UNITED STATES
DEPARTMENT OF THE INTERIOR
BUREAU OF LAND MANAGEMENT
SUNDRY NOTICES AND REPORTS ON WELLS

5. Lease Serial No.	NM-68084
6. If Indian, Allottee or Tribe Name	
7. Unit or CA Agreement Name and No.	
8. Well Name and No.	Mesa Verde 7 Federal 4
9. API Well No.	30-025-39586
10. Field and Pool, or Exploratory	Mesa Verde Bone Spring
11. County or Parish	Lea
State	NM

Devon Energy Production Company, LP respectfully requests approval to change the rig for this well to the Patterson 41. A rig layout is attached. We would also like to add the following language to our BOPE.

PECOS DISTRICT CONDITIONS OF APPROVAL

11" x 5,000 psi BOP Stack

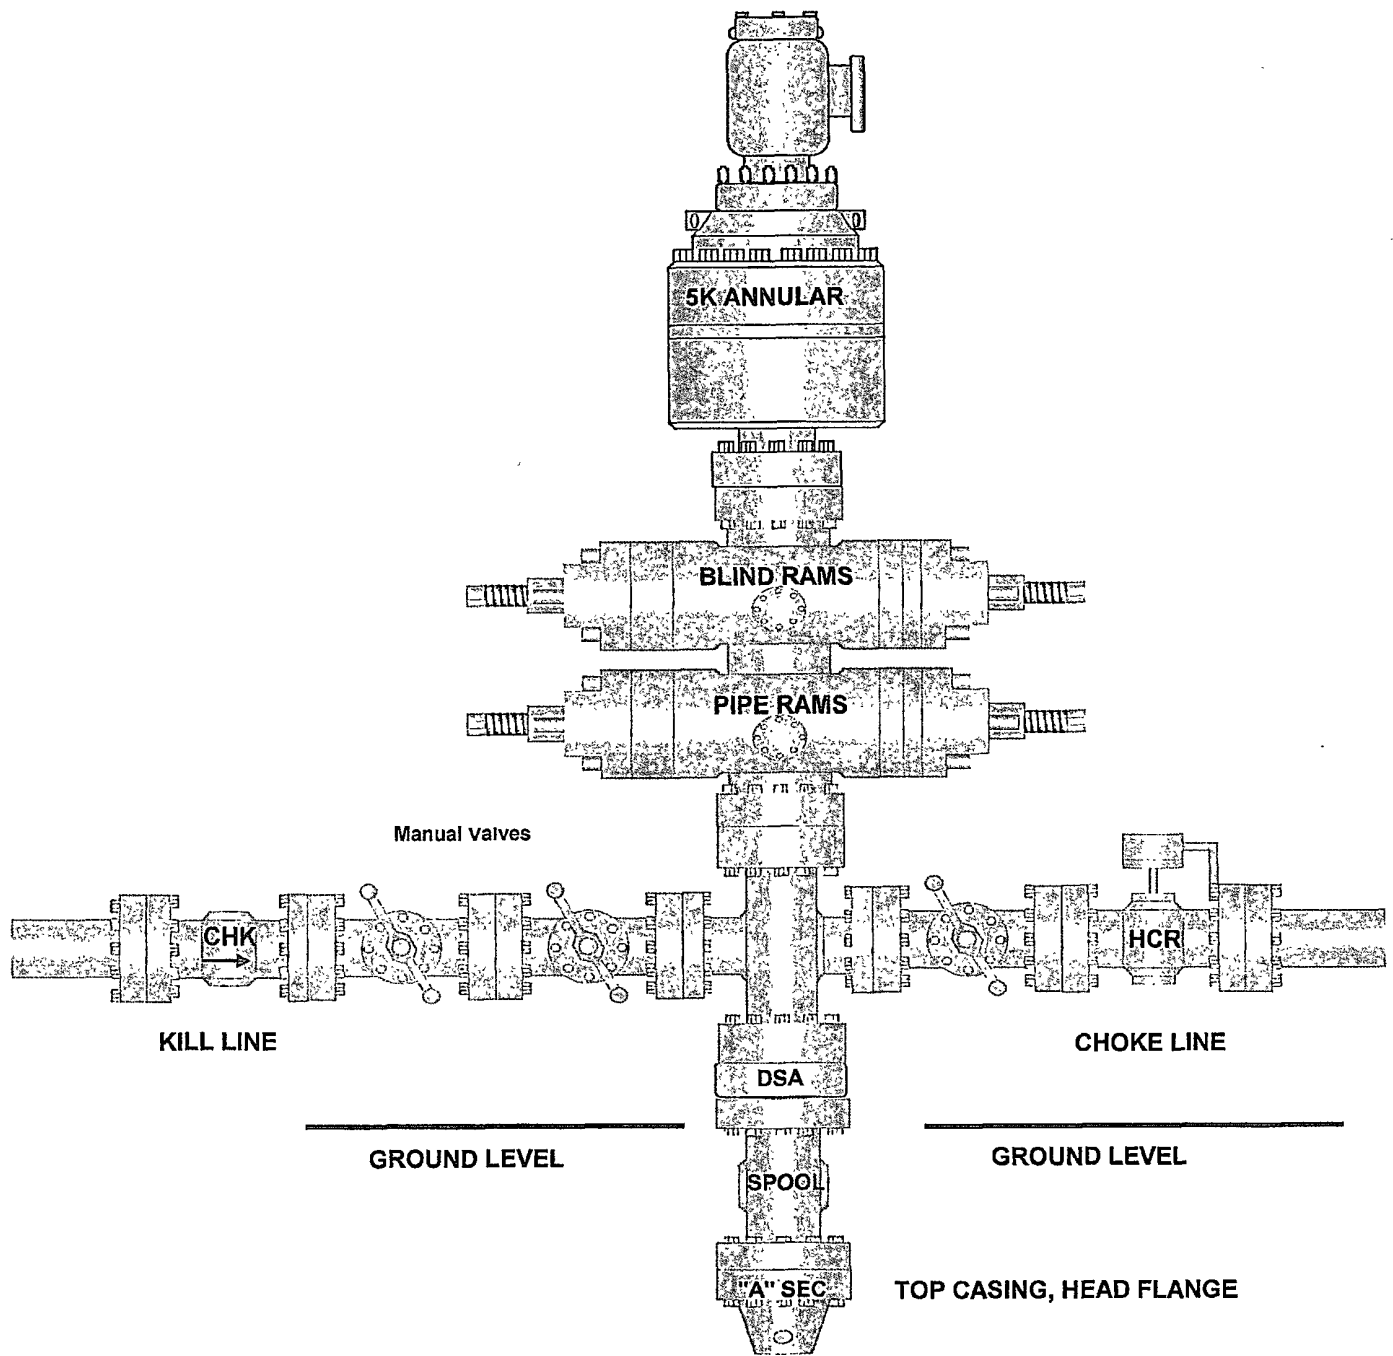
Pressure Control Equipment:

The BOP system used to drill the intermediate hole will consist of an 11" 5M Double Ram and Annular preventer. The BOP system will be tested as per BLM Onshore Oil and Gas Order No.2 as a 3M system prior to drilling out the surface casing shoe.

The BOP system used to drill the production hole will consist of an 11" 5M Double Ram and Annular preventer. The BOP system will be tested as per BLM Onshore Oil and Gas Order No. 2 as a 5M system prior to drilling out the intermediate casing shoe.

PRESSURE CONTROL:

2. Minimum working pressure of the blowout preventer (BOP) and related equipment (BOPE) required for drilling below the surface casing shoe shall be **3000 (3M) psi. Operator is using a 5M and testing as a 3M.**

3. Minimum working pressure of the blowout preventer (BOP) and related equipment (BOPE) required for drilling below the **8-5/8** intermediate casing shoe shall be **5000 (5M) psi. 5M system requires an HCR valve, remote kill line and annular to match. The remote kill line is to be installed prior to testing the system and tested to stack pressure.**
